DECLARATION OF WILLIAM HUGHEN

- 6. When I was a member of the Flex Team, I was assigned permit application related to a project at 200 Naples St. in San Francisco. The permit application was identified as PA 202108096049. I was assigned this project by my then supervisor, Natalia Fossi (formerly Kwiatkowska), on August 26, 2021.

- I reviewed the permit application and the plans submitted by Plaintiff in support of PA 7. 202108096049. I first reviewed the permit application itself. The permit application stated that it was "to comply with NOV 202175602: Addition of an ADU and the restoration of existing curb cut (per scope of work on the plans)."

Exhibit A

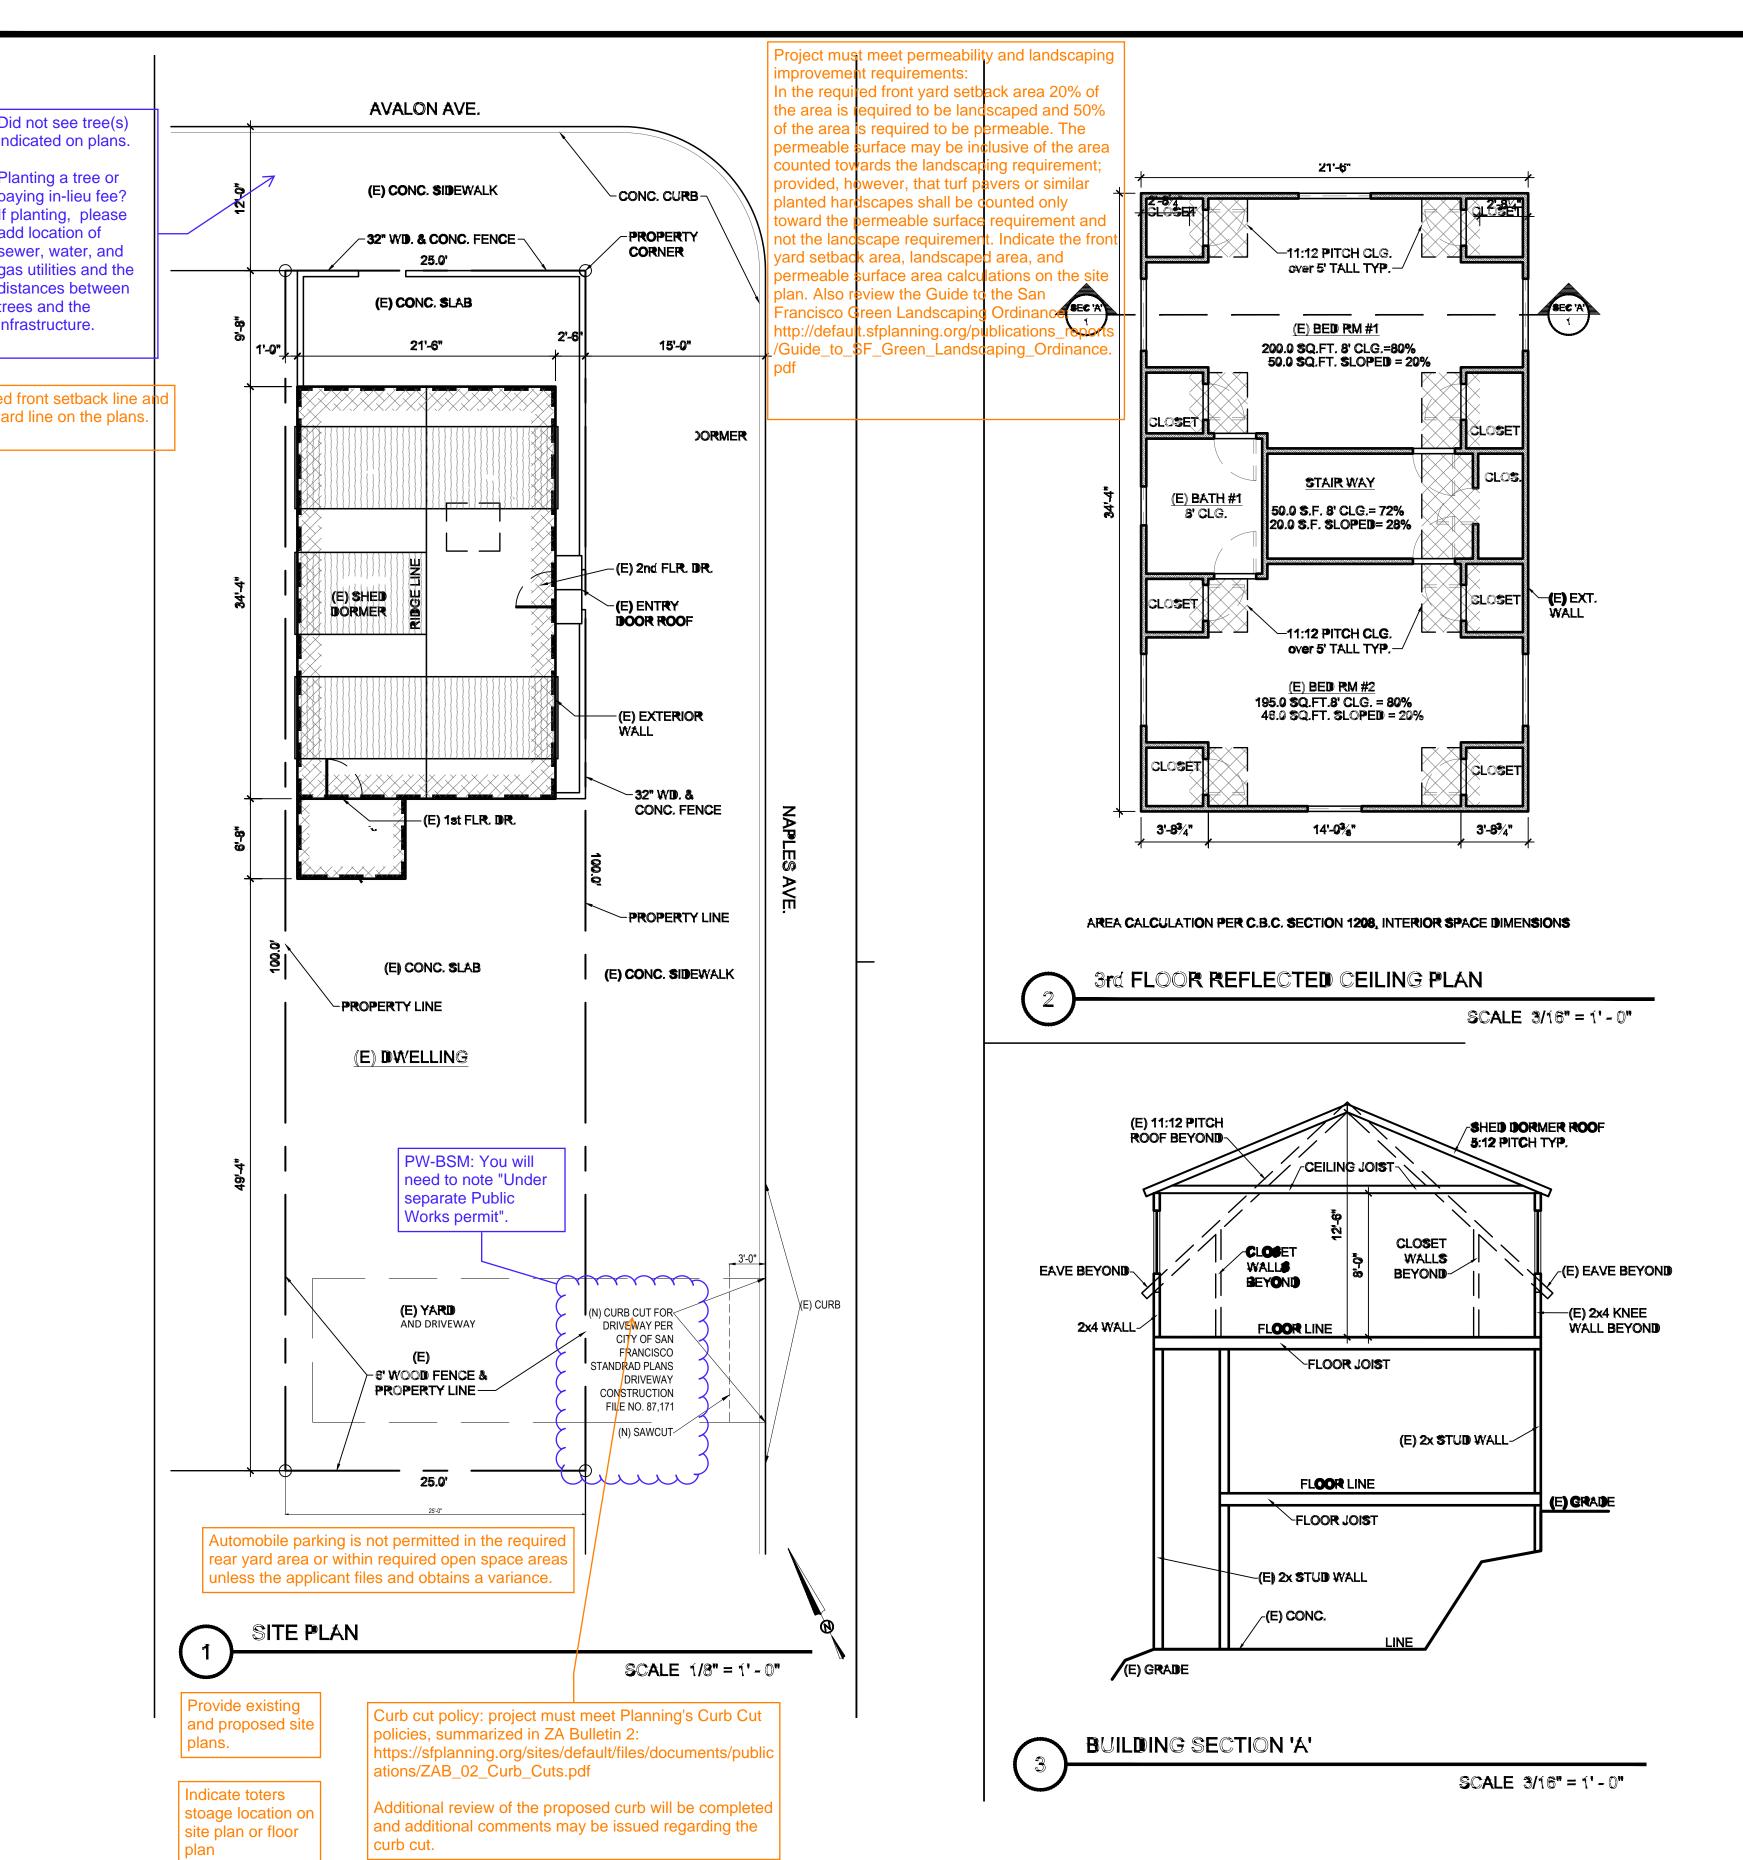
add location of

rees and the

nfrastructure.

pecify existing unit quantity and proposed unit quantity

In scope of work specify ADU will be added per Government Code Section 65852.2.

Please include the following notes:

- 1.Gas vent terminations shall meet the requirements of CMC 802.6 & SFMC 802.6.2.
- 2. Combustion air shall meet the requirements of CMC Chapter 7.
- 3. Environmental air ducts shall terminate 3 feet from the property line and 3 feet from openings into the building per CMC 502.2.1 and provide with back-draft dampers per CMC 504.1.1.

- 4.Domestic range hood vents shall meet the requirements of CMC 504.3 and comply with CMC Table 403.7.
- 5. Upper cabinets shall be a minimum of 30" above cooking top per CMC 921.3.2. Provide the cooking appliances minimum clearances to combustible materials per CMC 921.3.1.

- 6.All interior spaces intended for human occupancy shall be provided with space heating per CBC 1204.1.
- 7. Clothes dryer exhaust shall be a minimum 4 inches, terminate to the outside of the building, shall be equipped with a back-draft damper, and meet the requirements of CMC 504.4.2. Provide 100 sq. inch minimum make-up air opening for domestic dryers.

- 8.Direct vent appliances per CMC 802.2.4 (per manufacturer's installation instructions) and SFMC 802.6.2
- 9.Lighting per CEC 150.0(k)
- 10. Maintain rated separation between dwelling units per CBC 420.3. Penetrations through horizontal assemblies shall comply with CBC 714.4 & 717.6.
